October 16, 2000  
NG-00-1717

Subject: Duane Arnold Energy Center  
Docket No: 50-331  
Op. License No: DPR-49  
Technical Specification Change Request (TSCR-038):  
"Revised Pressure Temperature Curves"  
File: A-117

Proposed Change TSCR-038 to the Duane Arnold Energy Center  
Technical Specifications

Figure 3.4.9-1 (page 1 of 1)

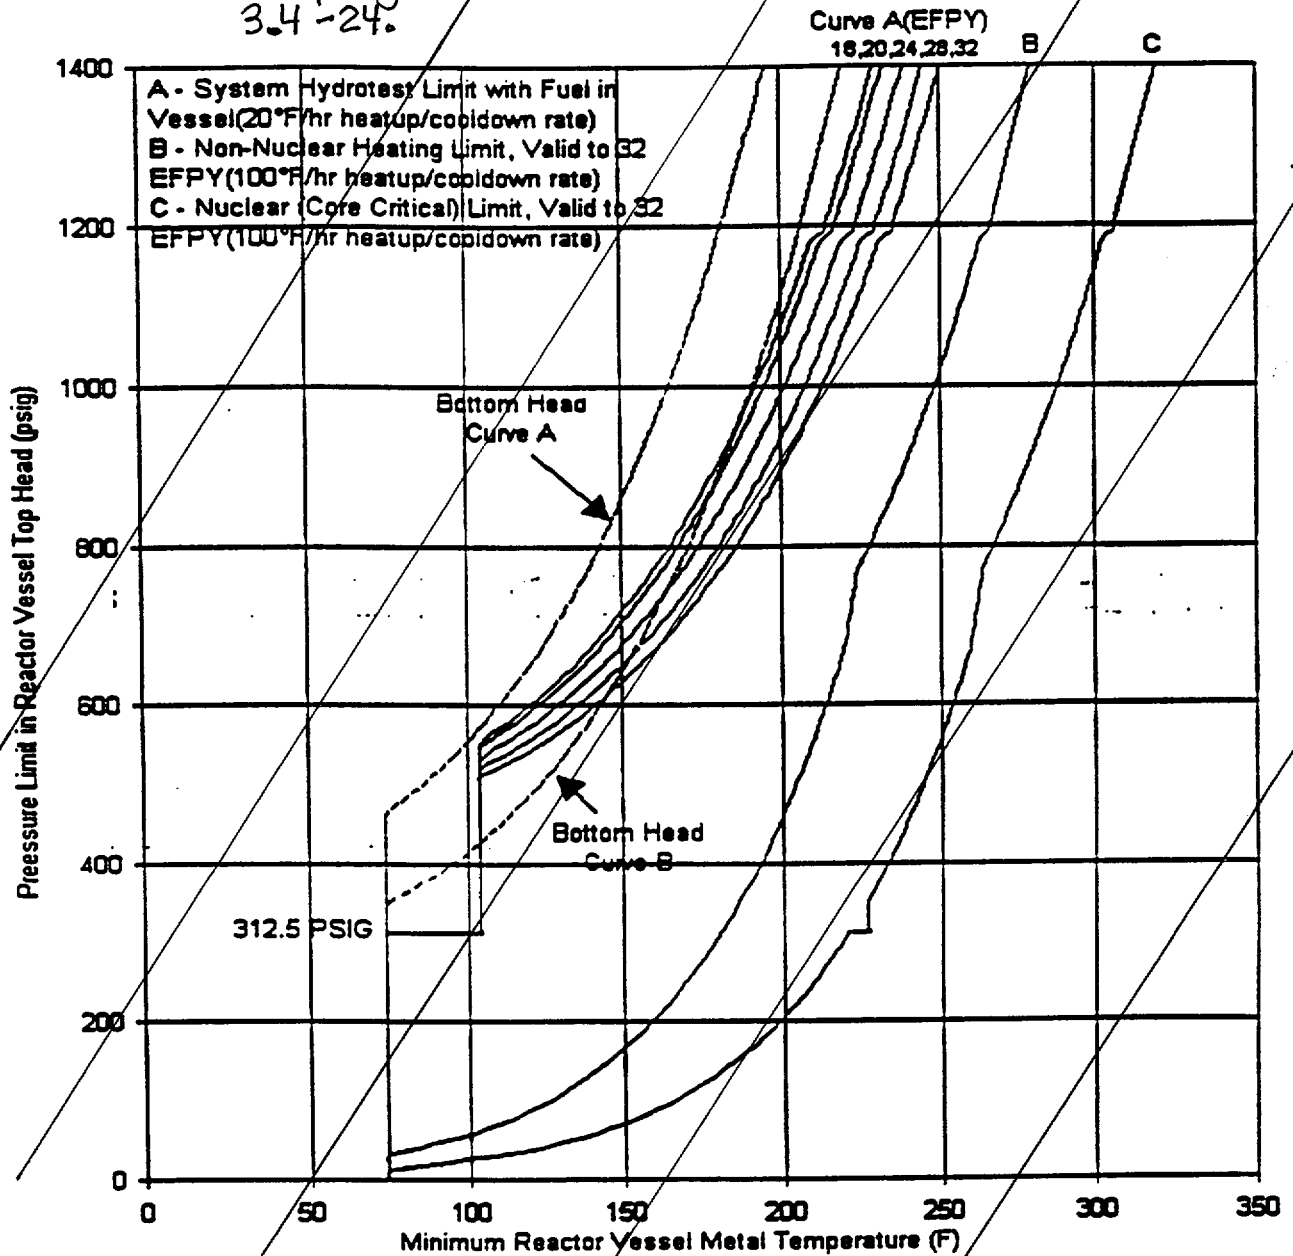
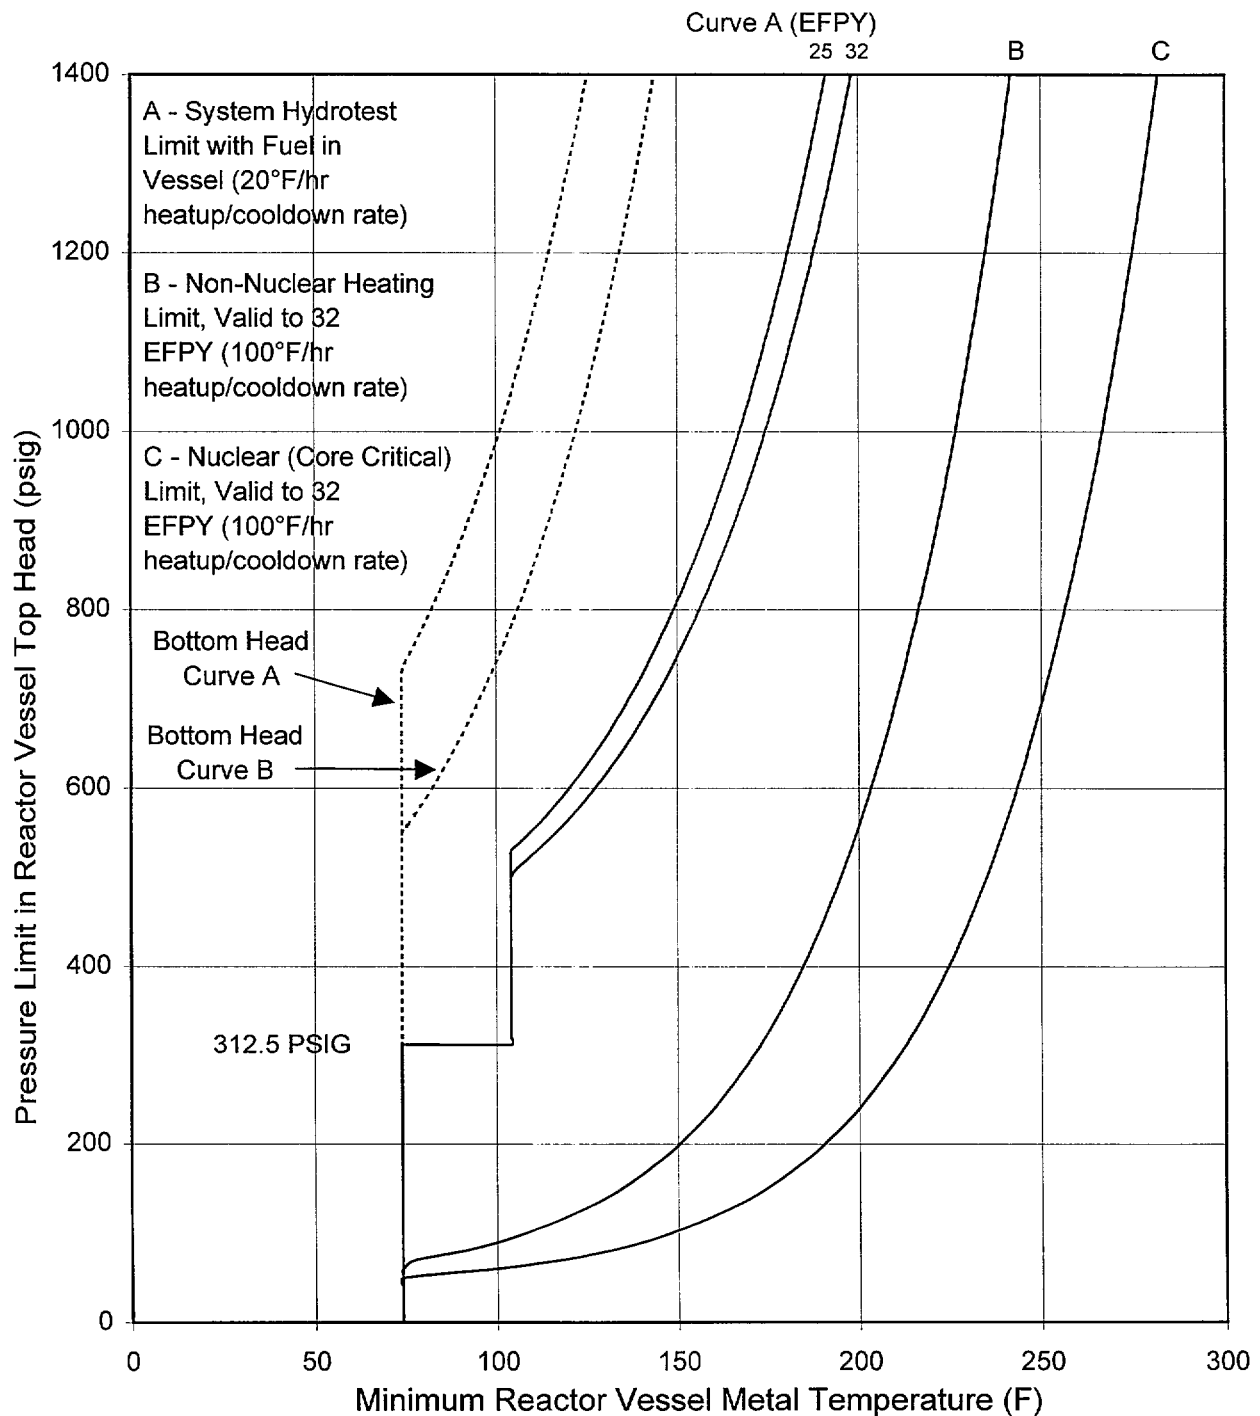
The proposed amendment updates Figure 3.4.9-1, "Pressure Versus Minimum Temperature Valid to Thirty-Two Full Power Years, per Appendix G of 10 CFR 50."

| <u>Page</u> | <u>Description of Changes</u>  |
|-------------|--|
| 3.4-24      | Figure 3.4.9-1 "Pressure Versus Minimum Temperature Valid to Thirty-two Full Power Years, per Appendix G of 10CFR50" is revised to incorporate new curves. |

NMC proposed to revise the DAEC TS requirements for reactor pressure vessel (RPV) P/T limits. Changes are proposed to Figure 3.4.9-1 which shows the P/T limit curves for inservice leakage and hydrostatic testing, non-nuclear heatup and cooldown, and criticality. No changes to the Limiting Conditions for Operation or any Surveillance Requirements of Technical Specification 3.4.9 are proposed.

Replace with  
new page  
3.4-24.
